**CANADA BAY LOCAL PLANNING PANEL  
EXTRAORDINARY MEETING**

*5 June 2019*

**ITEM 1            160 BURWOOD ROAD, CONCORD; PP2018/0003;  
PLANNING PROPOSAL**

A Planning Proposal has been received that seeks to rezone land at 160 Burwood Road, Concord from its current industrial zone to part residential, part neighbourhood centre and part open space. The site currently accommodates an industrial building and is known as the “House of Robert Timms” or the “Bushells Factory”.

*Proposed Floor Space Ratio*

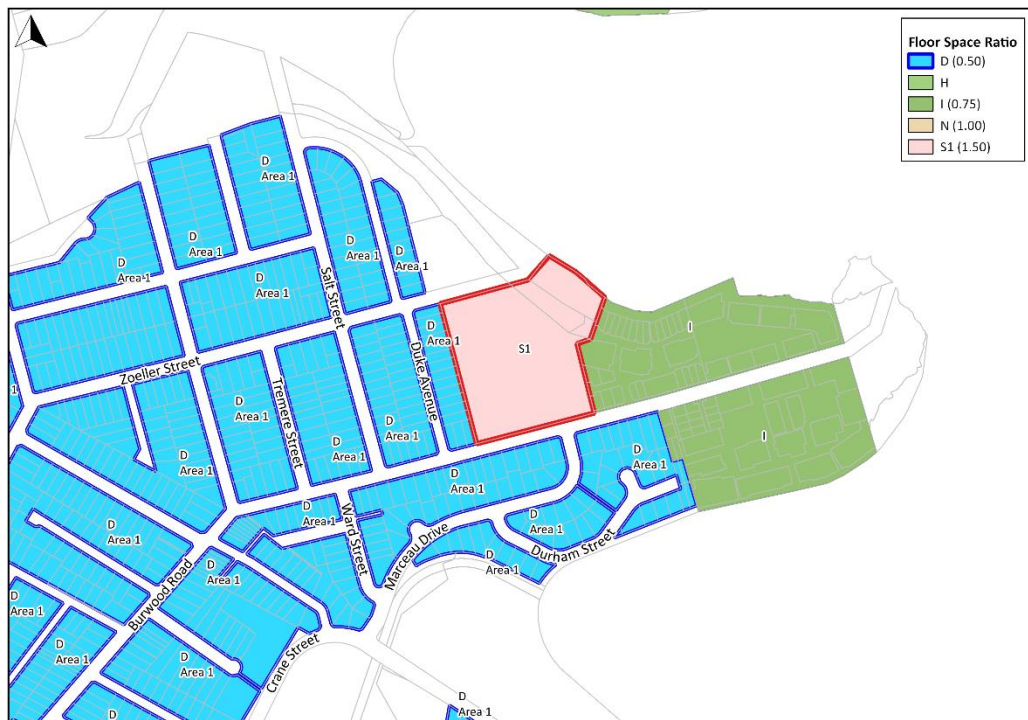
The Planning Proposal seeks to increase the permitted floor space on the site from 1.0:1 to 1.5:1. It is noted, however, that the Concept Plan submitted with the Planning Proposal achieves a Floor Space Ratio of 1.4:1.

The Planning Proposal is seeking development that is two times greater than has been achieved on similar sites in the area. The proposed density is even more uncharacteristic when it is considered the land to the west and south of the site has an FSR of 0.5:1 and the proposed development would be three times more dense.

In addition to a gross floor space ratio being applied across the site, it is also recommended that maximum net FSRs be provided for each Block. This outcome will provide certainty in relation to built form on each block. Refer to the recommended Floor Space Ratio Map below.

- (i) the Land Use Zones on the site being consistent with the Proposed Land Zoning Map provided as Attachment 4.
    - (ii) the Canada Bay Local Environmental Plan be updated to include a maximum gross Floor Space Ratio of 1.07:1 and a maximum floor space ratio per block as shown on the Floor Space Ratio Map, provided as Attachment 6.

*Proposed Height of Building*

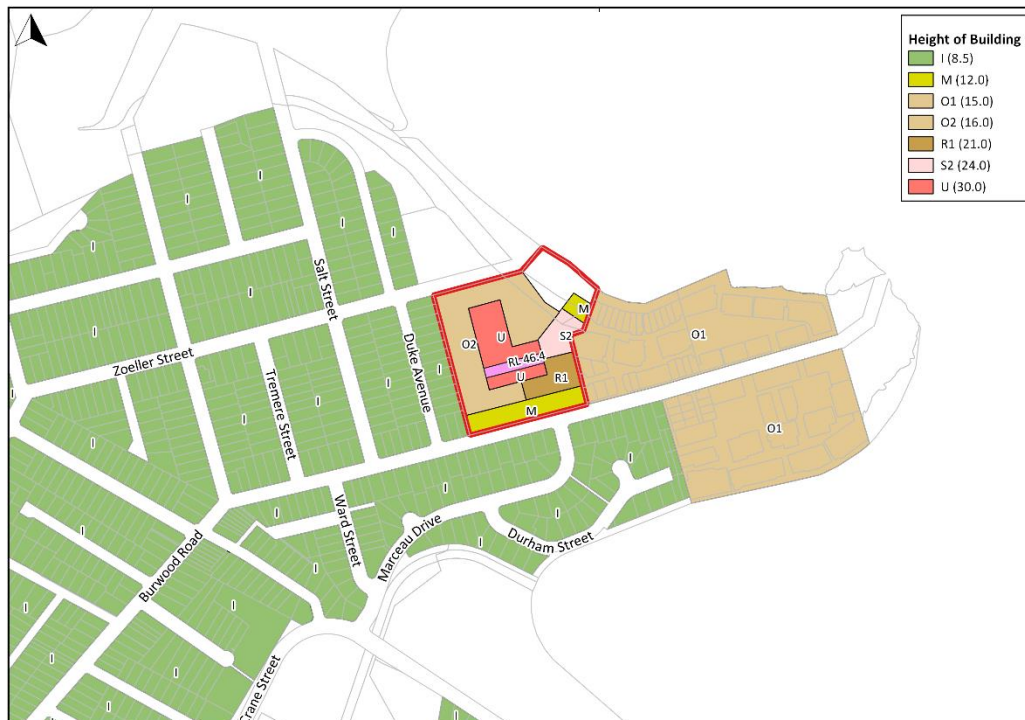
The Planning Proposal seeks building heights ranging from three (3) storeys up to five (5), six (6), seven (7) and nine (9) storeys.

Various heights are also identified on the proposed maximum height of building map that notionally exceed the height needed to accommodate the proposed number of storeys in the submitted concept plan. For example, 24m heights could potentially accommodate eight (8) storeys instead of seven (7) storeys and the 30m height limit could potentially accommodate ten (10) storeys instead of the nine (9) proposed.

- (iii) the maximum height of buildings on the site be reduced to be consistent with the Height of Building Map provided as Attachment 5.
    - (iv) the site being listed as a Local Heritage Item within the Canada Bay Local Environmental Plan and as shown on the Heritage Map provided as Attachment 7.

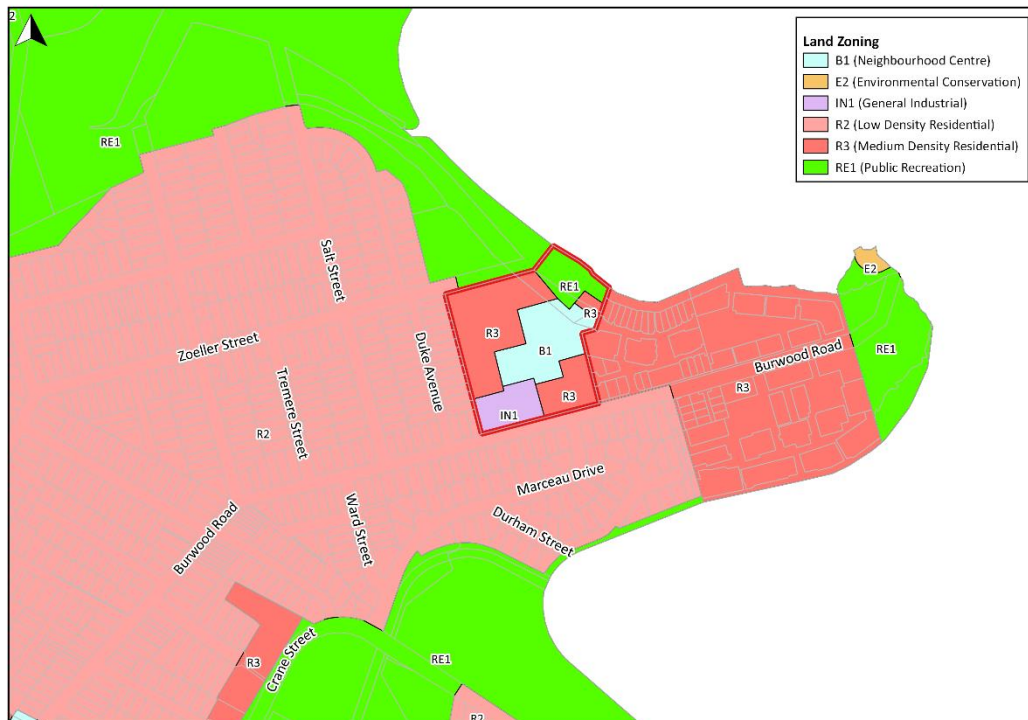
The concept drawings submitted with the Planning Proposal identify approximately 1,300sqm of urban services on the ground floor of Buildings C7 and C8.

Whilst “light industries” are proposed as an additional permitted use, the delivery of this use on the site will be at the discretion of the landowner and this outcome may not eventuate.

The location of the proposed urban services on the ground floor of Buildings C7 and C8 would also mean that light industrial uses are located between and below residential apartments. Even though low impact uses are expected, the industrial premises still require the ability to operate conflict free and have proper vehicular access and circulation. An astute design response is considered necessary so as to ensure that industrial tenancies incorporate high ceilings and adequate vehicle access, circulation and loading space. Light industrial uses should also ideally be located where interfaces with residential uses are minimised. If the configuration and layout is not suitable for urban services/light industrial uses, the success of the space will not be sustainable.

It is recommended that a “block” be identified within the site for urban services/light industrial. The block is to be zoned IN1 General Industrial and any future Development Control Plan should include design guidelines to ensure future buildings can function effectively and minimise impacts on surrounding residents. This approach will ensure that an appropriate design outcome can be achieved and the viability of the uses will be assured over time.

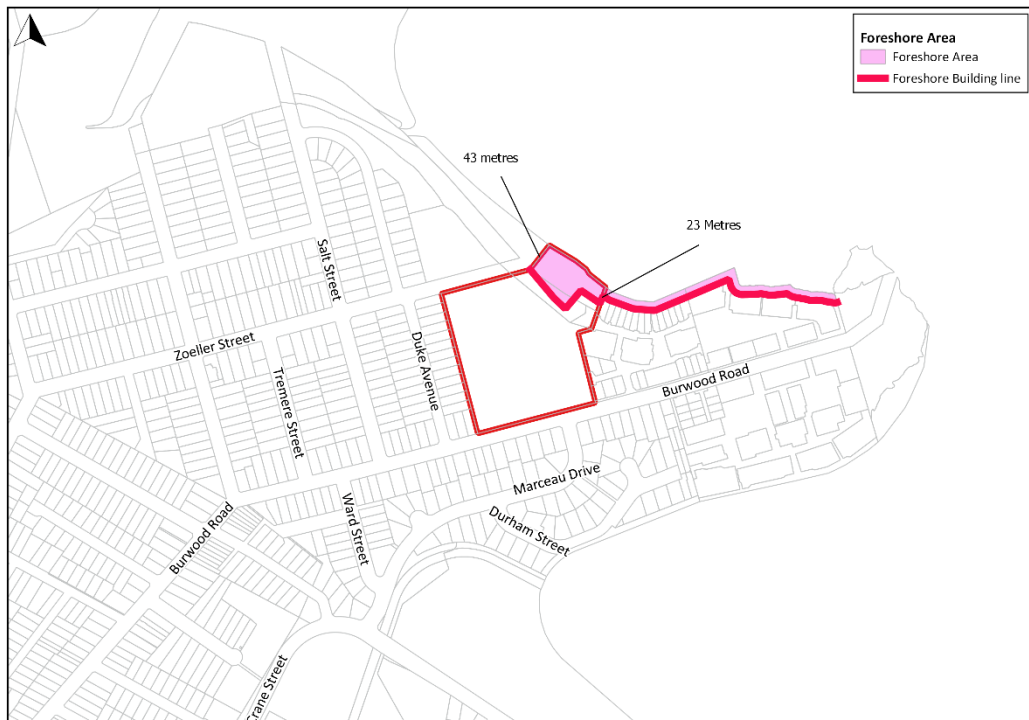
The Concept Plan also defines setbacks with “nominal” dimensions in place of “minimum” dimensions, which suggest that the dimensions may not be fixed. It is recommended that Council prepare a new Development Control Plan for the site that contains minimum setbacks, instead of nominal setbacks from boundaries.

A “nominal” 6 metres setback is proposed along the front (southern) boundary to Burwood Road. The Development Control Plan for Pelican Point, Pelican Quays and Phillips Landing required buildings to be generally set back nine (9) metres, with an absolute minimum of 7.5 metres at any point. To ensure a consistent building alignment to Burwood Road, it is recommended that the front setback to be a minimum of 7.5 metres.

A “nominal” setback of 12m has been provided along the eastern and western boundary to retain trees and minimise the visual impact of new buildings in Block 1 and Block 3. This setback is consistent with the minimum recommended setback contained within the *Apartment Design Guide* and is supported for a building that is three to four storeys high.
